AUDIO SERVICE

BULLETIN NO.:

08 - 81

SUBJECT: CR-2020

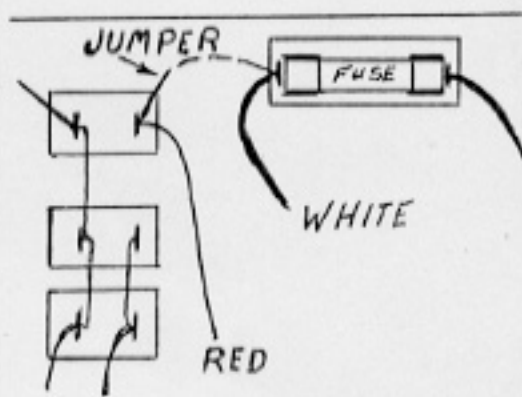
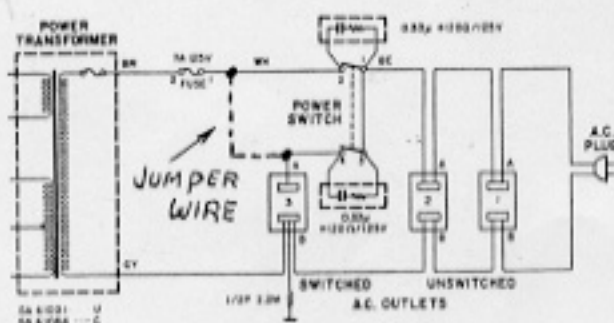
Problem: Power switch failure.

Cause: Pitting and burning of switch contact due to high current spike when set is switched off. (Back E.M.F. from power transformer).

Remedy: Replace power on/off switch (KA200630).
Install a jumper wire between the fuse holder (white wire) and the switched AC outlet (red wire).

Install the jumper wire on all units received for service that have not been modified.

ELECTROLYTIC CAP. C. BOARD

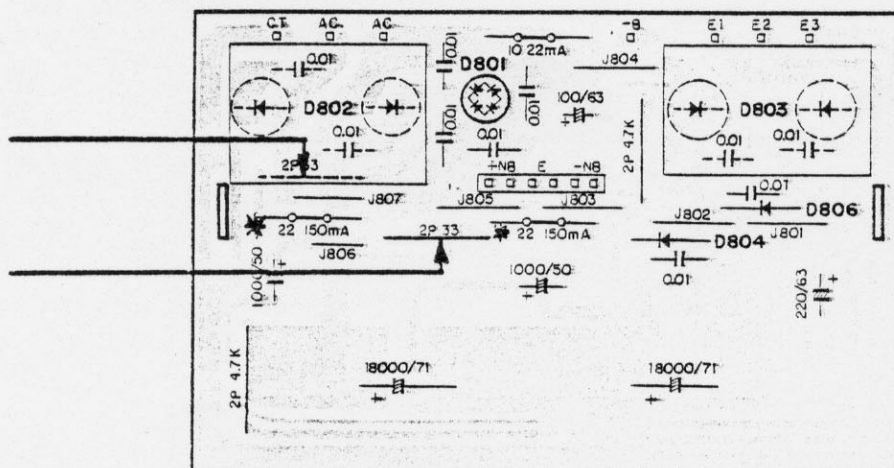
Problem: Intermittent power supply.
Receiver goes on and off, speaker relay clicking.

Cause: R 801 and R 802 (33 ohm) in electrolytic capacitor circuit board get hot and unsolder themselves.

Remedy: Remove both resistors and install new 33 ohm, 3 $\frac{1}{2}$ watt wire wound resistors.

Mount the resistors approximately $\frac{1}{4}$ inch away from the circuit board.

We suggest to use Ohmite #4374. These resistors are available from Yamaha Canada Music, Parts Department.

* Also replace the 22 ohm 150 mA fuse resistors with Ohmite #4369 22 ohm 3 $\frac{1}{2}$ watt resistors.
